August 23, 2022

SUBJECT: Dipsea Ranch (Weissman) Land Division (Tentative Map) and Mitigated Negative Declaration Amendment (P3546)

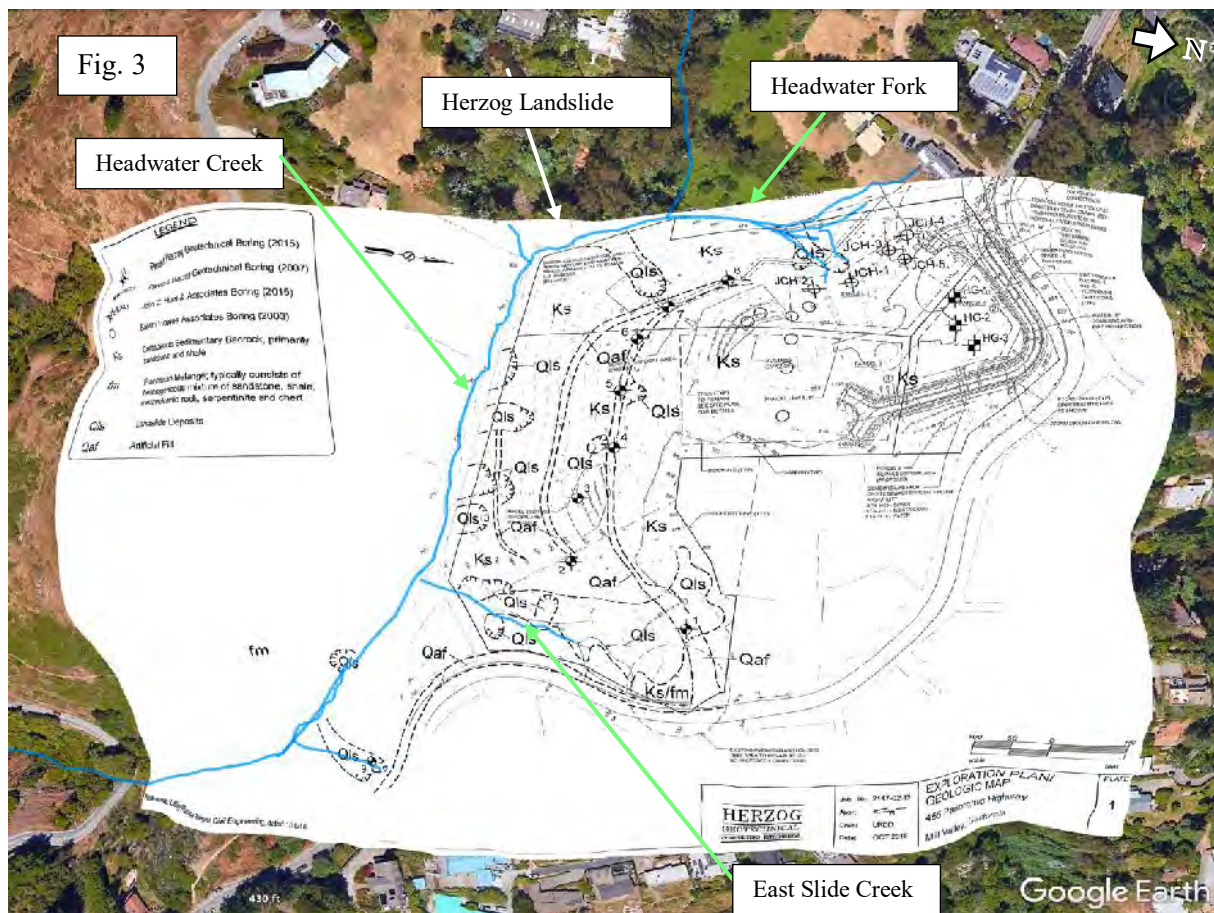
Figure 3 Shows the 2018 Herzog Exploration Plan/Geologic Map herein referred to as the Herzog Landslide Map (HLM) (note that even though the map legend on the image below says 2015 the map is also in the 2018 updated report with no apparent changes). It is not clear how the initial interpretation of landslides was conducted other than HGR referencing in their report that they performed a geologic reconnaissance of the site and reviewed selected geologic references. The HLM overlay looks wavy in Figure 3 because it is a 2-dimensional map fitted to topographic projection of Google Earth. The stream mapping by L. Collins has been left on to show the relationship of the key stream channels to the HLM, which are not delineated by Herzog. As can be seen, a multitude of information is provided on HLM but essential information concerning the on-site and off-site and stream network is entirely missing. The added blue line (from L. Collins mapping) is left on other Google Earth images in this report to show approximate channel locations and context. To address the #2) current condition of slope stability around the Fire Trail; and #3) the location of drainages on the property in relation to stream and conservation areas, any methods employed to divert water from these areas, and associated impacts from the drainages and diversion of water from those areas, this analysis copies and highlights key features of the HLM that are necessary for this review, including landslides (Qls), road fill (Qaf), existing and proposed sewage disposal areas, culverts, and lots.

In her description of Figure 3, the commenter states that,

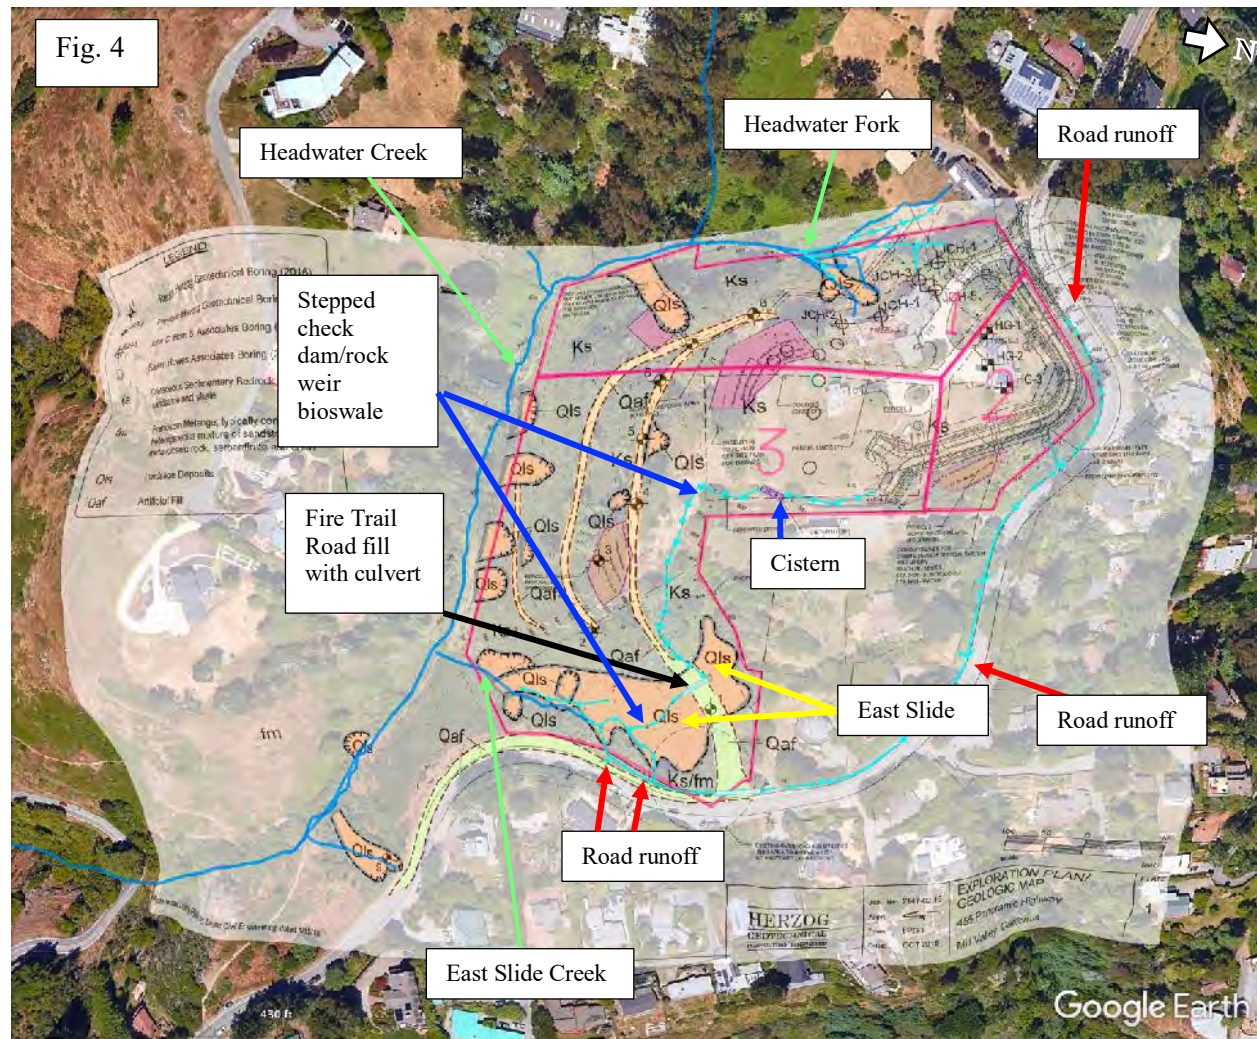
Figure 4 shows the key features of the HLM highlighted in different colors. The landslides (Qls) are shown as orange polygons with black outlines. One landslide, the largest delineated in the Project area by the HLM, is referred here as East Slide. It is located within the east side of Lot 3 and shown with a bright yellow arrow.

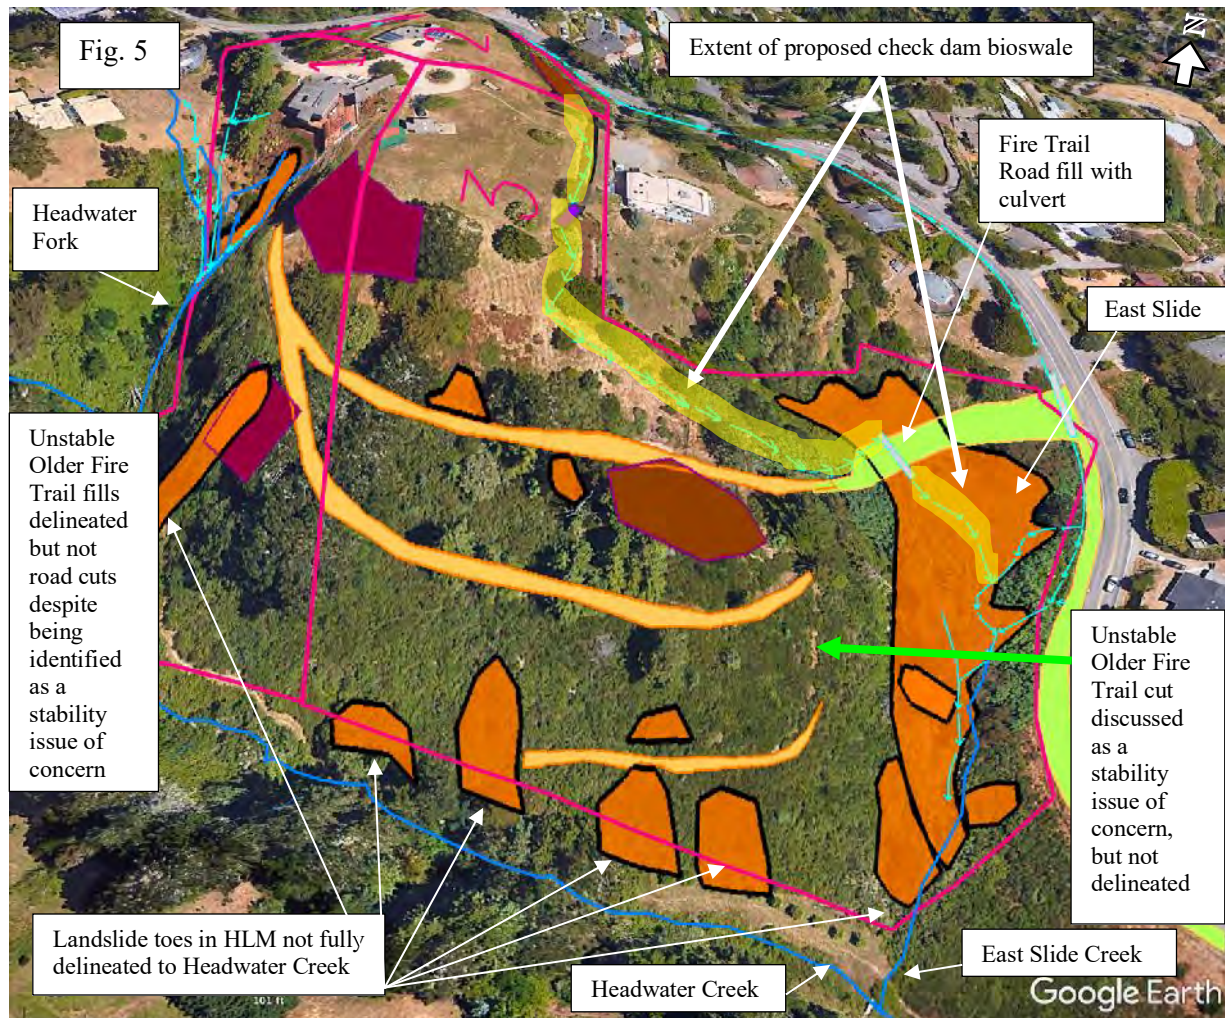
Figure 5 Shows the HLM overlay removed but the relevant features of concern were left on the 6/2019 Google Earth Imagery discussed in **Figure 3**. The proposed check dam bioswale that leads to the East Slide is highlighted here to distinguish it from the other proposed bioswales at East Fork and the existing road runoff along Panoramic Drive that drains into East Slide and East Slide Creek. The yellow line roughly approximates the boundaries shown in the Ziegler Conceptual Storm Water Control Plan (AR 2156.) that will be subject to grading, erosion control fencing, and filter berms (AR 2165.).

Although the Older Fire Trail fills (light orange linear polygons identified as the Qaf geologic unit) are delineated in the HLM, Herzog consultants did not map the extent of unstable road cuts in the Project area even though they discussed them in the HGR. The thick green arrow in [Figure 5](#) points to the area of the road cut of the Older Fire Trail that is discussed as unstable in both the original and updated Herzog Geotechnical reports, but it is not delineated in the HLM.

Neither of the unstable Older Fire Trail cuts or fills are discussed in the IS/MND or Amendment. The failure to address the mapped and discussed geologic features of the Older Fire Trail fills and the discussed features of Older Fire Trail cuts implies that Sicular lacks understanding of the importance of geotechnical discussions about stability. This leads to mistakes in conclusions about significance of Project impacts because these features were omitted from any analysis. In additions, potential impacts of unstable Older Fire Trails on destabilizing mapped landslides (both uphill and downhill of the trails) should have been evaluated in the IS/NMD or Amendment because their instability can transport sediment directly into the on- and off-site Headwater and East Slide Creeks. Sicular's lack of expertise in geotechnical issues and resulting failure to evaluate identified unstable features indicates to me that the IS/MND and Amendment conclusions about impacts being less than significant are unfounded and inconclusive because of incomplete analysis of identified unstable features (landslides and Older Fire Trails).

[Figure 5](#) also shows that the HLM does not map the full extent of the landslides toes that are adjacent to Headwater Creek and beneath East Slide Creek at its confluence to Headwater Creek. Showing and evaluating these connections is essential because the linkage of sediment supply from unstable landslides to the stream network is demonstrated. This should ultimately signal and justify the need for evaluation of potential increased sediment supply to downstream threatened and endangered fish habitat in Redwood Creek. Not only is the activity status and

In Figure 5, the commenter states that slope instability associated with the "Older Fire Trail" cuts or fills is not discussed in the IS/MND or Amendment. That statement is not correct. The smaller landslides (slumps) present along the unimproved access roads are discussed on page 79 of the IS/MND:

Figure 5 also shows that the HLM does not map the full extent of the landslides toes that are adjacent to Headwater Creek and beneath East Slide Creek at its confluence to Headwater Creek

- 4-18 In Figure 5, the commenter contends that there was an incomplete mapping effort related to geotechnical issues. As discussed previously, Herzog completed a preliminary geotechnical investigation of the property, which includes a review of site conditions, a site reconnaissance, and preliminary recommendations. This level of investigation typically does not include the in-depth mapping effort that Ms. Collins believes should have been completed. Herzog evaluated the site preliminarily with the understanding that a design level geotechnical investigation would be completed at a later stage of Project design.

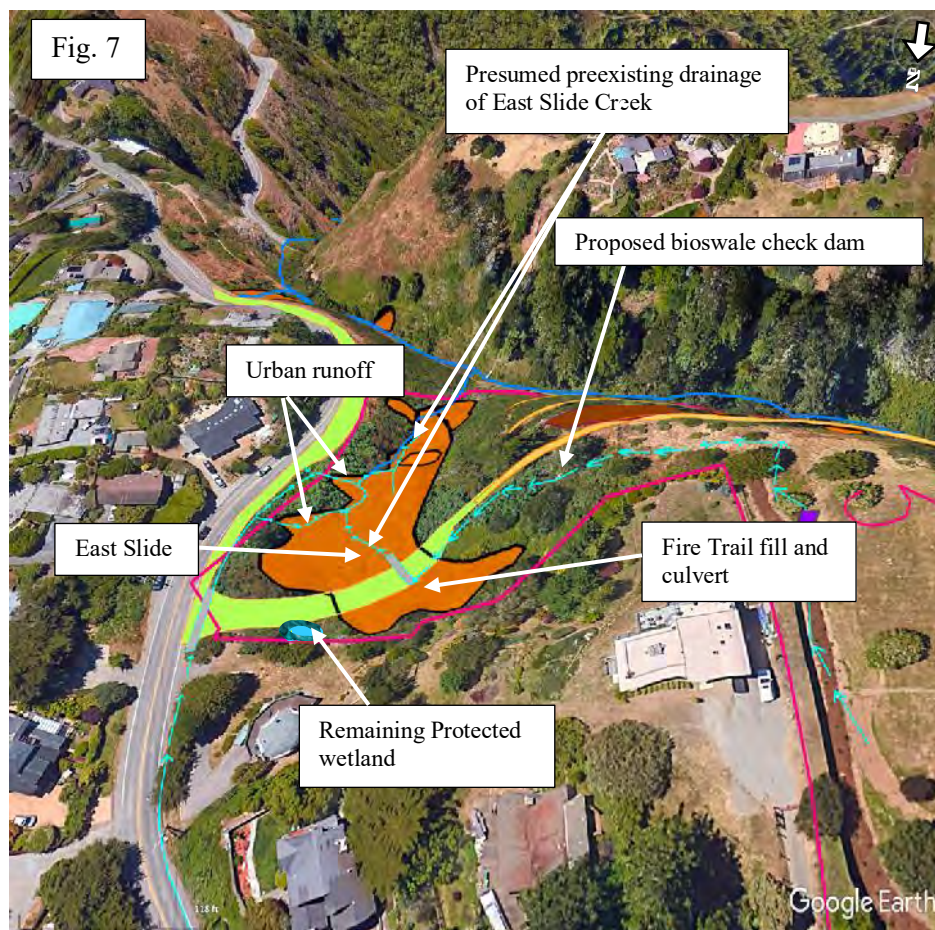
In [Figure 8](#) a former wetland tributary is shown to be flowing (yellow arrows) from the wetland into the area that is now buried with 1200 cubic yards of fill for a road that technically cannot be used for fire protection due to its lack of engineering standards. Here a blue arrow has been inserted to indicate a possible preexisting channel that required drainage at the fill that does not lead to the wetland. On the other hand, it could also lead into what appears to be the lateral scarp of the East Slide delineated on the HLM and here sketched as a white line. This landslide is presently the base of support for the Fire Trail fill. No known efforts were undertaken to stabilize the East Slide by dewatering it or redirect water draining into that contributes to its saturation and instability.

The commenter’s interpretation of the features in Figure 8 are, yet again, based on speculation. The area of green vegetation represents a topographic low where drainage from the slope and Fire Road to the east (toward Panoramic Highway) collects and ponds. This area was covered when the Fire Road fill was placed but this is also the location that the culvert was installed to facilitate drainage and avoid surface water impoundment behind the newly placed (2014) Fire Road fill. The statement that the preexisting channel (marked by the blue arrow) “could also lead” to the lateral scarp of the East Slide is unfounded and is not based on field observation. Contrary to the commenter’s claim, the culvert was installed beneath the 2014 Fire Road fill in an area that received local surface water drainage in order to dewater and redirect flow and avoid surface water contributing to erosion of the Fire Road fill.

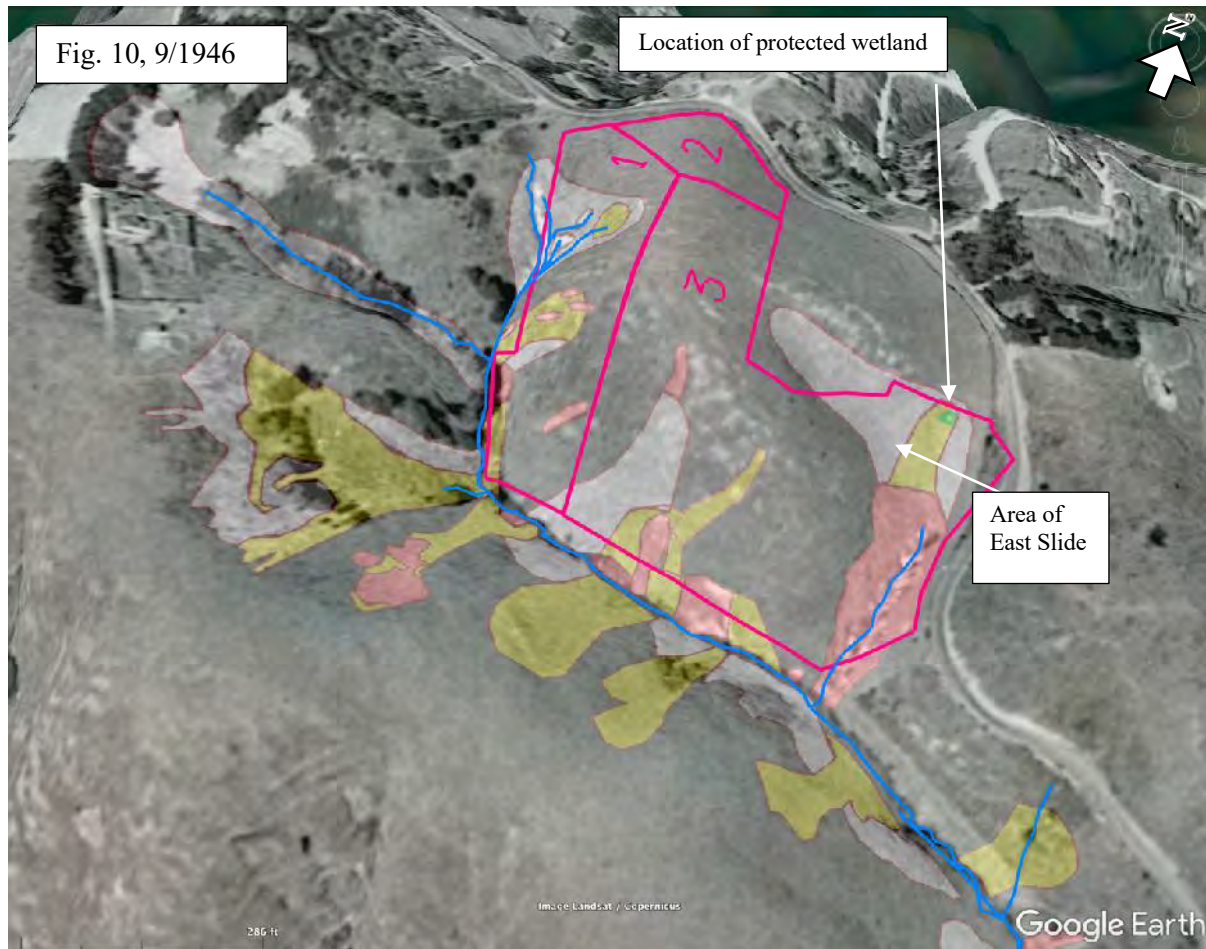
Figure 10 shows the same 9/6/1946 Aerial Photo GS-CP 5-2 overlaid onto Google Earth Imagery, but it also shows the same channel mapping of the stream network by L. Collins depicted in Figures 2 and 3, and the Project Lot lines (pink lines). It also delineates interpreted landslides from the 1946 imagery. Landslides mapped as red polygons were likely active < 50 years prior to 1946, perhaps by the turn of the 1900s (76 years before present), while landslides mapped as yellow polygons were likely active sometime during the 1800s (between 76 and 222 years before present). Landslides mapped as white polygons likely predate European settlement and could include very old landslides that predate impacts of European settlement to ancient slides that were last active during or shortly after the end of the Pleistocene Epoch (>222 years before present and less than 11,700). On Mount Tamalpais, these latter slides can commonly be colluvium filled hollows that can look like topographic swales of lack little topographic expression at the topographic depressions (zero-order basins) above heads of channels. The colluvium-filled hollows can fail catastrophically as debris slides during very intense and/or prolonged rainfall events (S. L., W. E. Dietrich, C. J. Wilson, and J. D. Rogers, Colluvial deposits and associated landslides in the northern San Francisco Bay area, California, USA, Proceedings of the 4th International Symposium on Landslides, pp. 425-430, 1984).

Some of the landslides mapped in Figure 9 appear to be colluvium filled hollows, while others appear to range from shallow debris slides, simple rotational slumps, to complex deep-seated earthflows that can have multiple failure planes (slip surfaces within the body of the slide). The nature of sliding at the East Slide area looks like it has had a history of shallow debris sliding and slumping near the head scarp of the white polygon and deeper-seated earthflow movement within the body of the white polygon. The yellow polygon, within the white-colored, older slide area, appears to have been active sometime between the 1800s and 1946. It is conservatively depicted as older than the recently active portion of the East Slide, as represented by the red polygon below the yellow one. As can be seen in Figure 9, gullying by East Creek is deeply incising the lower active portion of East Slide within the red polygon.

In my interpretation, East Slide is a large complex earthflow, exhibiting multiple modes of failure that have occurred over a broad time span. East Slide is active in some areas and as discussed in the HGR, it displays hummocky and lobate topography indicative of previous earthflow landsliding (AR 01822). The body of the East Slide mapped

- 4-19 In Figures 9 through 26b and associated discussion, Ms. Collins presents a lengthy evaluation of historic slope instability on the property and on adjoining parcels based on aerial photography from select years (1946, 1955, 1965, 1987, 1993, 2002, 2007, 2008 2013). However, as stated in the response to comment 4-14, the method used to identify and map landslide features is questionable. Aerial photographic interpretation is but one tool used by geologists to determine previous landsliding, but the process, when carried out correctly, requires high resolution, stereo-pair photographs viewed through a stereoscope, producing a 3-dimensional effect with an exaggerated vertical component. Ms. Collins did not use the stereo pairs approach but rather relied on importing single-frame digital images into Google Earth, resulting in a low-resolution, quasi-3-D effect. This approach provides some information, but it is grounds for questioning the validity of the commenter’s interpretations, and is not the best-available source of information.

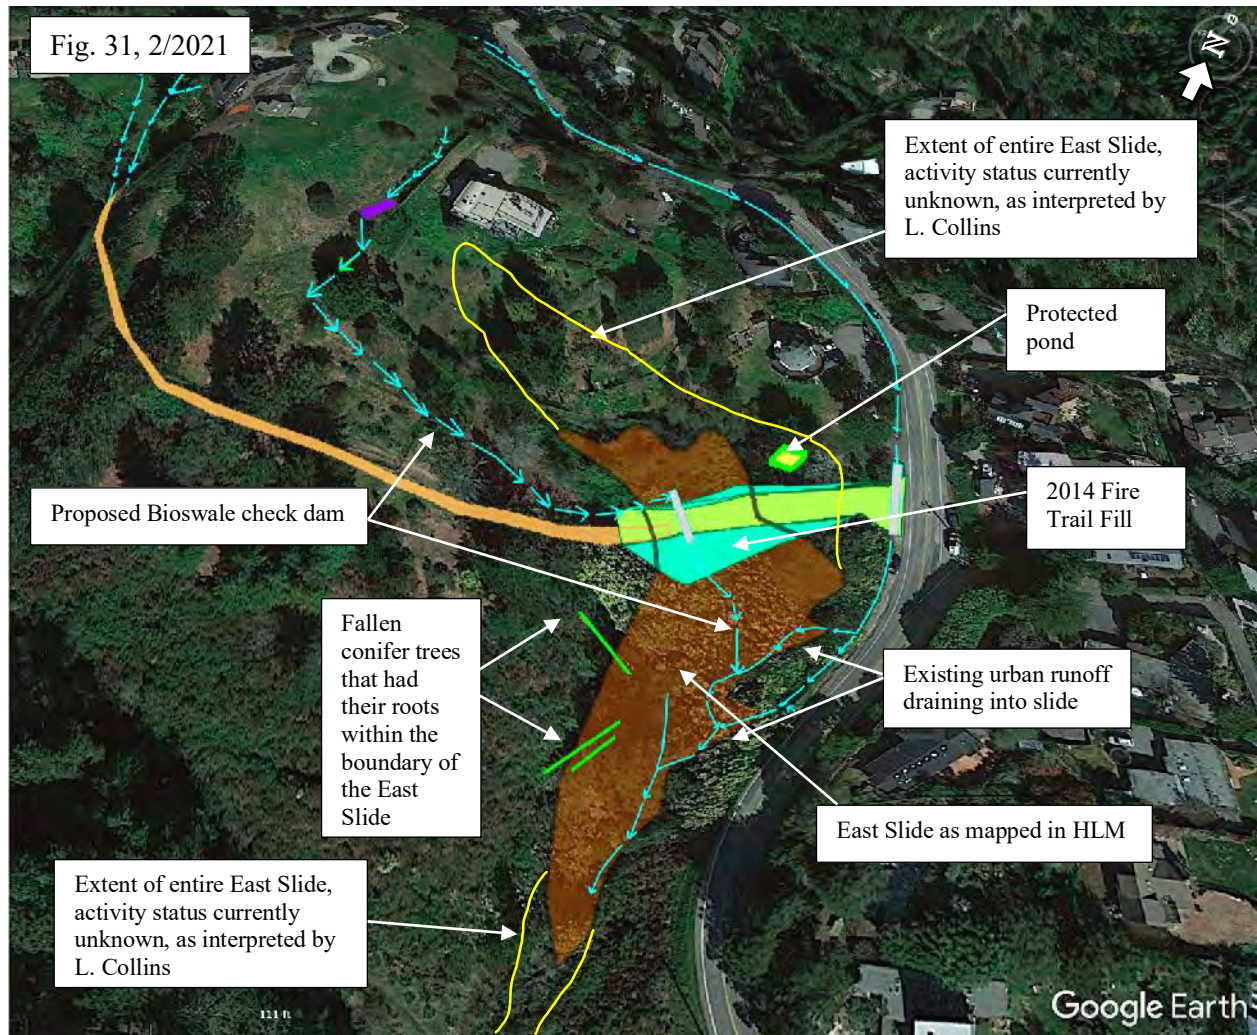
Figure 31 shows the same tree fall as Figure 30. The trees were rooted within the body of the East Slide mapped in the HLM. The figure also shows the larger extent of the East Slide as mapped for this report (Figures 10, 13, and 15). The yellow lines above the east slide show the greater extent of the crown scarp, while the yellow lines at the bottom of the figure show the extent of the toe of the slide. It is likely that other smaller trees show evidence of ongoing instability within the slide, but it is difficult to identify them unless they are very large. Field access, mapping and verification could resolve this.

A further illustration of Ms. Collins’ misinterpretation of the “East Slide” is shown on Figure 31 in comment 4-21, where she superimposes yellow outlines at her interpreted upper and lower extent of the “East Slide,” and labels this area *“Extent of entire East Slide, activity status currently unknown, as interpreted by L. Collins.”* This type of geologic interpretation is not only erroneous but dangerously misleading. A licensed Professional Geologist or Certified Engineering Geologist would not have made such a baseless interpretation. Ms. Collins did not evaluate the boundaries of this feature in the field, nor does she offer any concrete evidence that her sketched boundaries: actually represent the extent of the “East Slide;” these yellow demarcations are based on aerial photographs and speculation and are nothing more than lines drawn on a map. The “slide” area identified by Ms. Collins extends beyond that which was field-mapped by Herzog, a qualified and licensed geoscience professional, in 2015.
